# ATEX Certification Report

Conductix, Inc Documentation Update

Author:		Adam Traverse Approvals Engineer
Mentor:		Richard Tunnicliffe Engineer
Checked:		Andrew Dickinson Consultant Engineer
Report number:		101418288MAN-001
Date:		January 2014

Retractable Grounding Assembly (RGA)

**Figure 8: Horizontal Mounting Bracket with RGA Assembly**

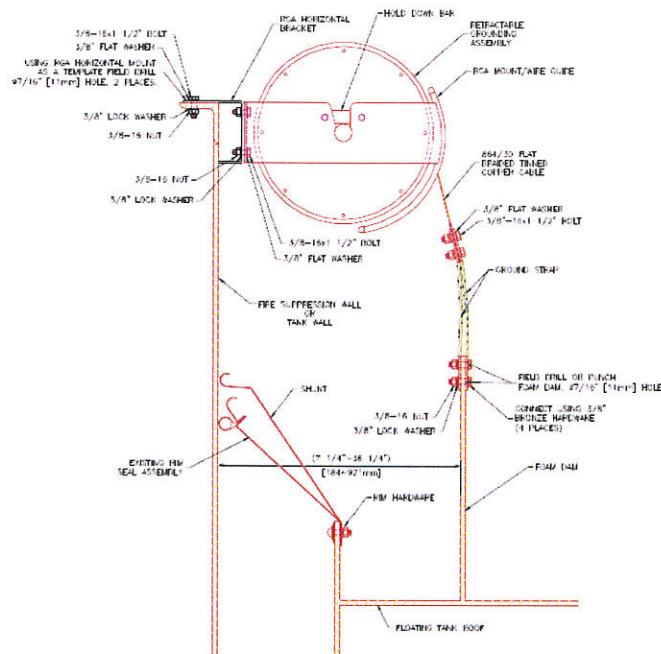
The Ground Strap is pre-drilled for connection to the tank roof. The RGA will operate properly on roofs where this Ground Strap can be installed directly below the RGA and should be 7 ¼"~ 36 ¼" [184~921mm] from the tank wall as shown in Figure 8.

**Figure 9: RGA Front View, Welded Foam Dam Shown**

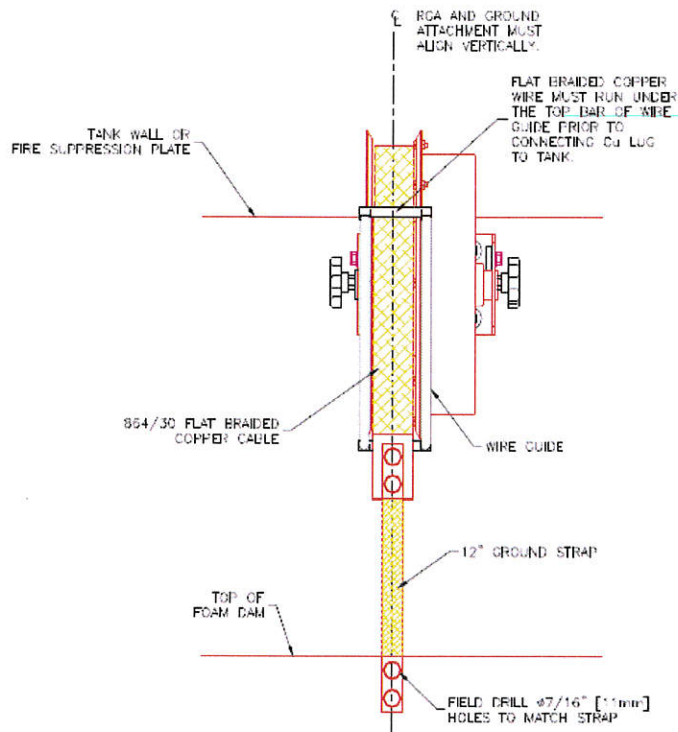
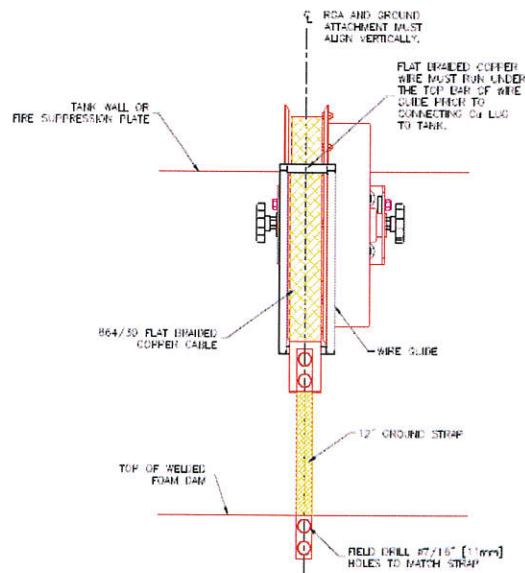
The attachment point on the floating roof foam dam **must align vertically** with the center of the braided cable wire, as shown in Figure 9. To facilitate vertical alignment, the RGA should be installed when the tank is at its fullest capacity. A 'plumb bob' or laser level can be used for best possible results (caution – a 'plumb bob' should be utilized when the wind is calm). Maintaining vertical cable alignment within +/- 12" [305mm] will minimize cable wear and maximize cable life. Once you locate the attachment point, create two (2) 7/16" [11mm] diameter holes using the Ground Strap as a template, see Figure 10. Scrape paint and rust from around the drilled holes to bare metal. Apply Lectra Shield to both sides of the holes to prevent rusting.

RGA straps may not be attached to a bolted foam dam as seal fabric and gasket material prevent the establishment of an acceptable electrical connection between the straps and tank roof. If the tank has a bolted foam dam, additional mounting hardware will be required and the bolted foam dam strap installation procedure below must be followed. Regardless of foam dam type, the attachment point on the floating roof **must align vertically** with the center of the braided cable wire, as shown in Figure 9. To facilitate vertical alignment, the RGA should be installed when the tank is at its fullest capacity. A 'plumb bob' or laser level can be used for best possible results (caution – a 'plumb bob' should only be utilized when the wind is calm). Maintaining vertical cable alignment within +/- 12" [305mm] will minimize cable wear and maximize cable life.

**Figure 8: Foam Dam Types**

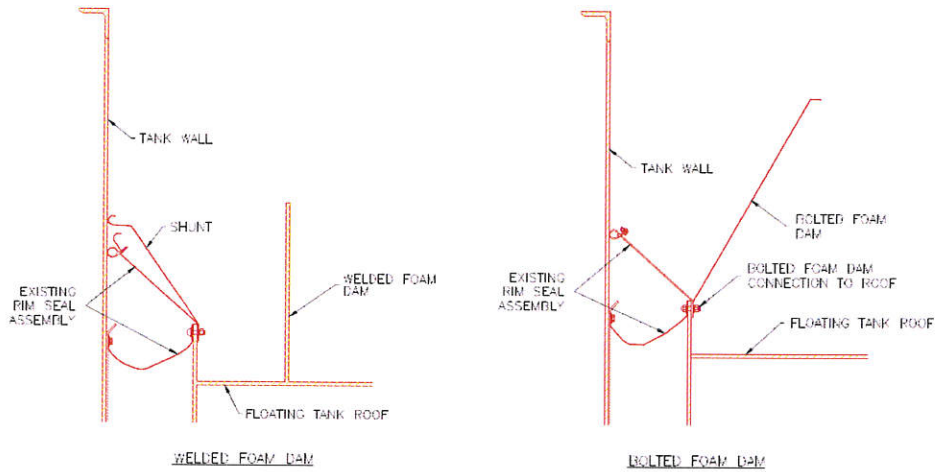
**Foam Dam Types** – Two methods are commonly used to attach foam dams to floating roofs, as illustrated below. The sketch on the left shows a typical foam dam which is welded directly to the floating roof. It generally consists of an approximately ¼ [6.4mm] thick piece of steel, approximately 18 – 24 [457 – 610mm] tall, that is rolled to the approximate diameter of the tank and welded directly to the floating roof. The sketch on the right shows a typical bolted foam dam connection which generally consists of a series of 18 – 24 [457 – 610mm] wide plates which are bolted to a welded portion of the floating roof. These foam dam plates are typically mounted over the primary and secondary seal fabric, as well as any gasket material, thereby resulting in an unacceptably high impedance between the foam dam and floating roof.

**Figure 10: Welded Foam Dam RGA Installation**

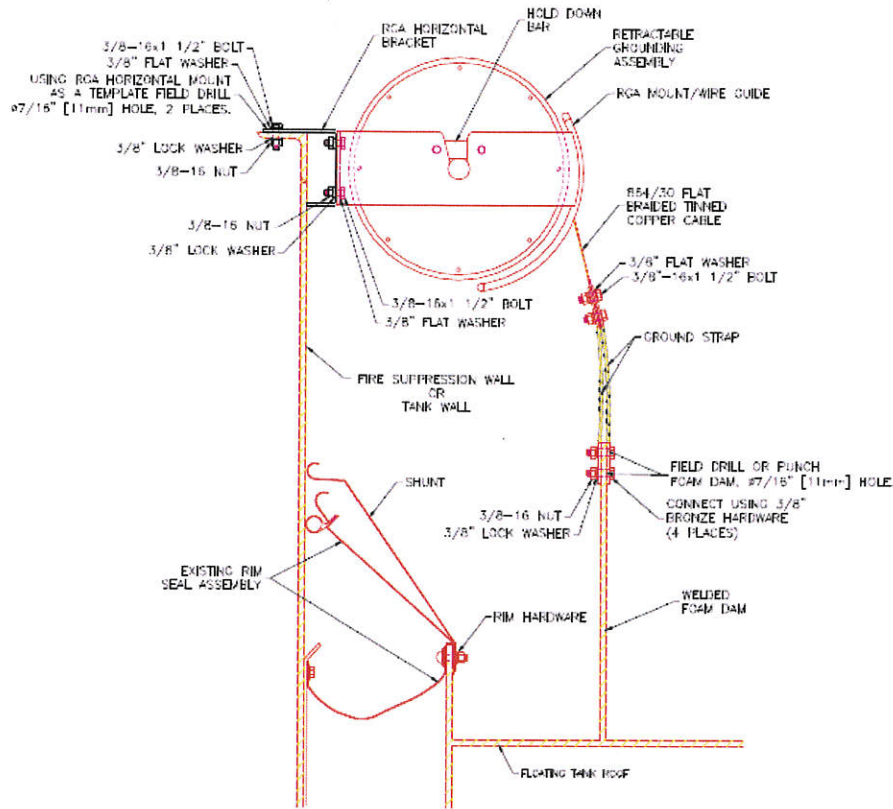
**Welded foam dam strap installation** – If the foam dam is welded to the roof, as shown in Figure 10, then the instructions below should be followed in order to attach the RGA straps to the foam dam.

Locate an attachment point to the welded foam dam that is vertically aligned with the RGA, then create two (2) 7/16" [11mm] diameter holes using the Ground Strap as a template, see Figure 11. Scrape paint and rust from around the drilled holes and under the ground strap mounting surfaces to bare metal. Apply Lectra Shield to both sides of the holes and all bare metal to prevent rusting.

**Figure 12: Bolted Foam Dam RGA Installation**

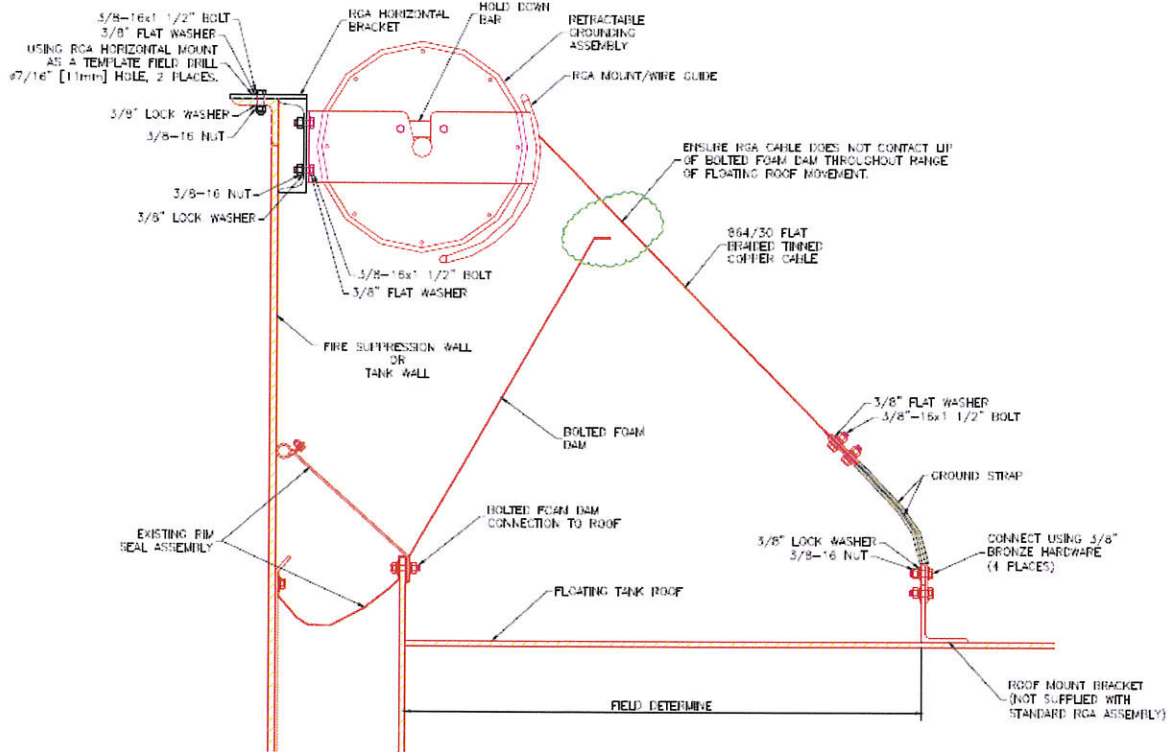
**Bolted foam dam strap installation** – If the foam dam is bolted to the roof, as shown in Figure 12, then the instructions below should be followed in order to attach the RGA straps to the tank roof.

Locate a level portion of roof that is vertically aligned with the RGA and sufficiently inboard from the tank wall so that the RGA cable and straps will not rub against any portion of the bolted foam dam as the tank roof rises and falls, as shown in Figure 12. The RGA cable and straps will be nearest to the lip of the foam dam when the tank is at its fullest and the roof is near the top of the tank.

Scrape paint and rust on the roof to bare metal where the custom roof mount bracket (not included in standard RGA installation kit – bracket must be ordered separately) will be placed. Weld the bracket all the way around to the tank roof. If welding is not possible, the bracket may be temporarily attached to the roof by drilling and tapping two (2) 3/8" holes, using the bracket as a template. If the bracket is bolted to the roof, it should be welded in place during the next maintenance shutdown or when feasible to do so.

Apply Lectra Shield to the welded or bolted connection to prevent rusting.
